**CULTURAL RESOURCES OFFICE
PRESERVATION BOARD
REGULAR MEETING
MONDAY MAY 19, 2014 — 4:00 P.M.
1520 MARKET ST. #2000
www.stlouis-mo.gov/cultural-resources**

DATE: May 19, 2014
ITEM: Preliminary review to construct concrete trail in Bellerive Park and revise parking area in Sister Marie Charles Park
ADDRESS: 5570 S. Broadway and 154 E. Elwood Street
JURISDICTION: S. Broadway Bluffs Landmark District #43 and City Parks — Ward 11
STAFF: Jan Cameron, Cultural Resources Office

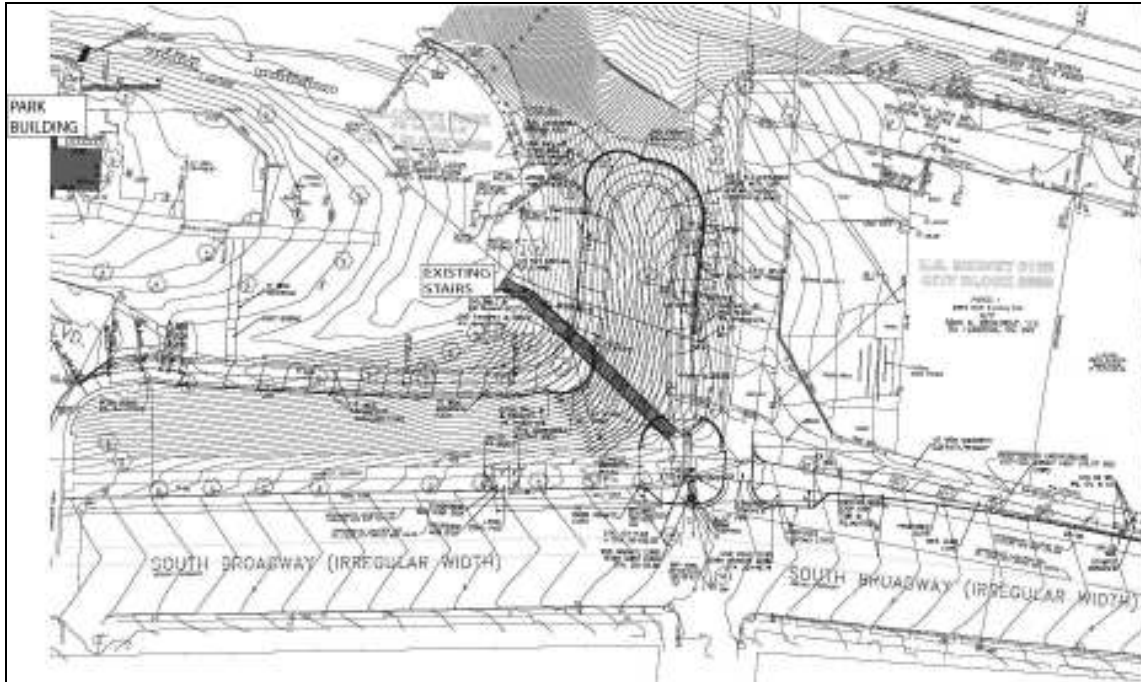
Proposal comments:

While the project proposes a pedestrian/biking trail which may provide a desired amenity in Bellerive Park, it is important that the historic characteristics of this urban park are not compromised. Introduction of the concrete trail and its accoutrements will have a definite effect upon the appearance and topography of the park, requiring some regarding and alteration of the existing slope, primarily at the southern end where the trail will descend to Dover Street. The trail will include two lookout areas, requiring retaining walls; a fence/rail; and a monument-flanked entry at Dover Street. Design of these elements have not been finalized. The historic stone stair (which has a matching stair on the north end of the park) is a character-defining feature and must be considered in any proposed alteration.

PROPOSED TRAIL IN BELLERIVE PARK (PARK BUILDING & STAIR SHOWN SHADED)

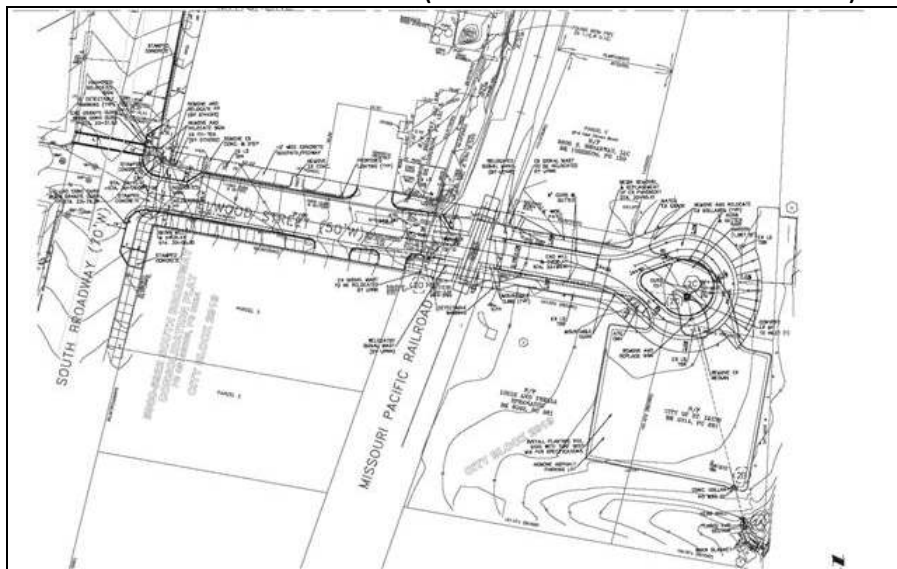
CRO is concerned that the trail proposed for Bellerive Park, which will require alteration of the topography of the bluff and the removal of a historic stone stair at the southern corner of the park, will have a significant impact upon the existing historic character of the park, park structures and Bellerive Bridge. CRO staff has met with representatives of Great Rivers Greenway, the Board of Public Service; the Parks Department and the Carondelet Neighborhood Association and discussed ways to mitigate the impact of the project.

PROPOSED NORTH ELEVATION

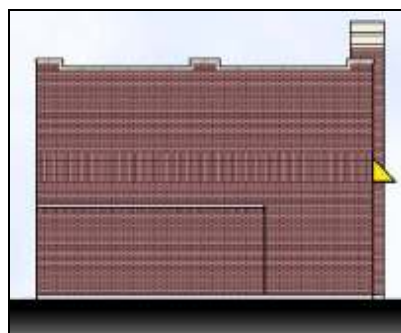
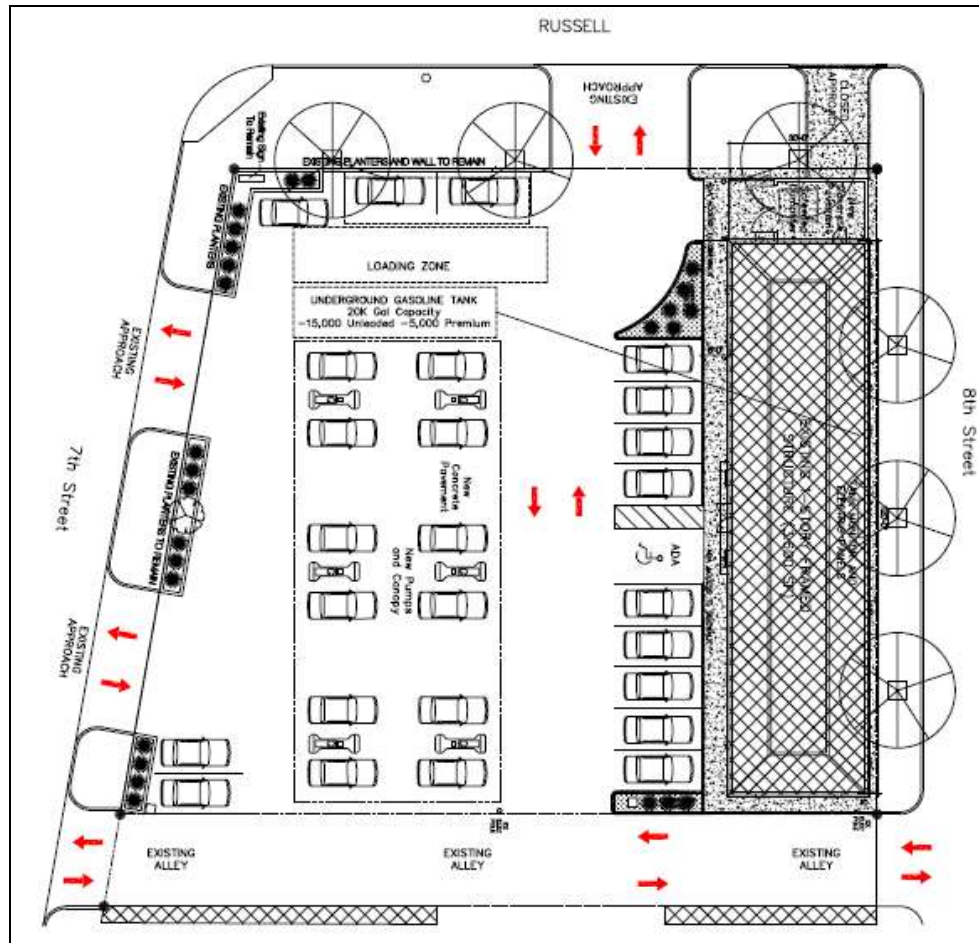
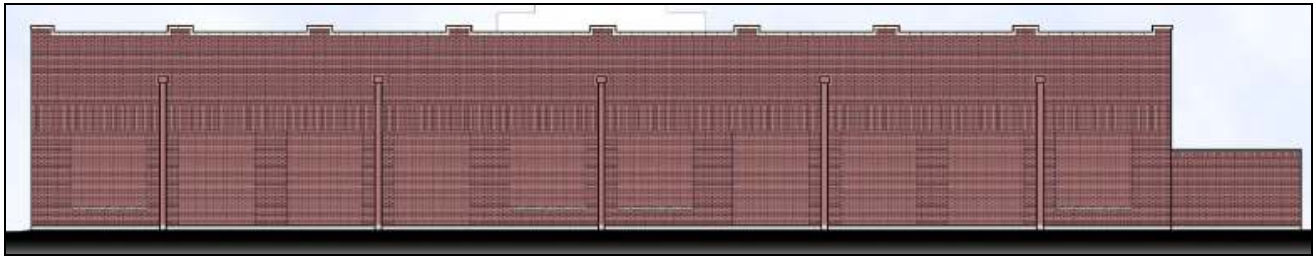
The applicant has not provided a single Model Example for the proposed new construction; however, much of the design is based on industrial and commercial buildings within the historic district. Given the nature of the use of the property, the rationale for the use of and ability to find an appropriate Model Example are limited.

Complies. A single-story commercial building is on the site to the north as well as several other examples along 7th street to the south. A Phillips 66 gas station south across Russell has recently been redeveloped with a similar plan and a one-story brick building and canopy over the gas pumps; the two service stations will appear similar in scale and comparable properties.

Complies. All four sides of the new construction are proposed to be brick veneer.
